Access Compliance Report

Public Rights-of-Way

(Curb Ramps)

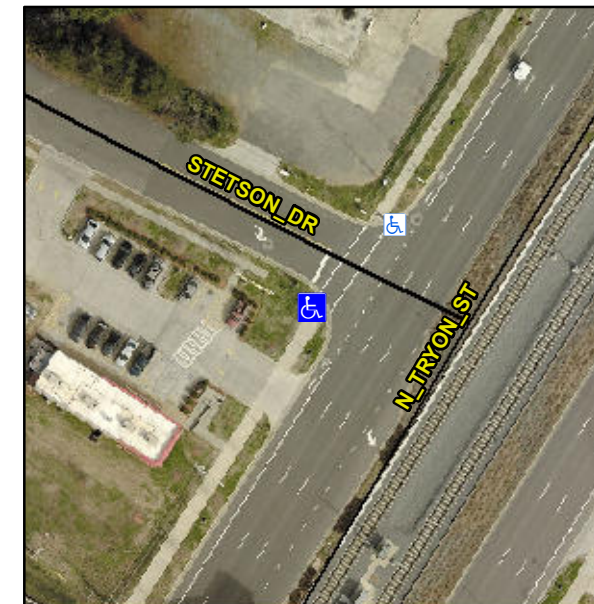
Intersection ID: 6774	Main Street: STETSON_DR	Cross Street: N_TRYON_ST	Location:	W
ADA ID: B5C429337868	Ramp Type: Perp	Initial Pass/Fail: Fail	Overall Compliance: No	Severity Score: 12.5
Codes/Mitigation Info/Possible Solution		Field Measurements/Component Compliance

Compliance	Description	Data	Compliance	Description	Data
N/A	Ramp Length (in)	256.0	Yes	Ramp Slope (%)	9.3
Yes	Ramp Width (in)	92.0	Yes	Ramp XSlope (%)	0.3
N/A	Flare Type LT	N/A	N/A	Flare Type RT	N/A
N/A	Flare Slope LT (%)	N/A	N/A	Flare Slope RT (%)	N/A
N/A	Flare Traversable LT?	N/A	N/A	Flare Traversable RT?	N/A
N/A	Landing Length (in)	N/A	N/A	DWS Provided?	N/A
N/A	Landing Width (in)	N/A	N/A	DWS Contrast?	N/A
N/A	Landing Slope (%)	N/A	N/A	DWS Length (in)	N/A
N/A	Landing X Slope (%)	N/A	N/A	DWS Full Width?	N/A
N/A	Landing Curb? (Y/N)	N/A	N/A	DWS Offset (in)	N/A
N/A	Shared Landing?	N/A			
N/A	Gutter Ponding?	N/A	N/A	Gutter Slope (%)	N/A
N/A	Gutter Lip Ht (in)	N/A	N/A	Gutter X Slope (%)	N/A
N/A	Painted X Walk1?	Yes	N/A	Painted X Walk2?	N/A
	X Walk 1 Direction	To NE		X Walk 2 Direction	N/A
N/A	X Walk 1 Width (in)	110.0	N/A	X Walk 2 Width (in)	N/A
	X Walk 1 Slope (%)	2.8		X Walk 2 Slope (%)	N/A
	X Walk 1 X Slope (%)	4.7		X Walk 2 X Slope (%)	N/A

N/A	Ramp inside XWalk1?	Yes	N/A	Ramp inside XWalk2?	N/A
	Road Slope (%)	N/A	N/A	Clear Space?	N/A
	Road X Slope (%)	N/A	N/A	Clear Space to XWalk (in)	N/A
N/A	Any Obstructions?	N/A	N/A	Storm Grate/Utility Hazard?	N/A
	Obstruction Type			Storm Grate/Utility Type	
			N/A		N/A
			Yes	Surface Condition? (G/P)	Good

Remove & Replace Entire Ramp.
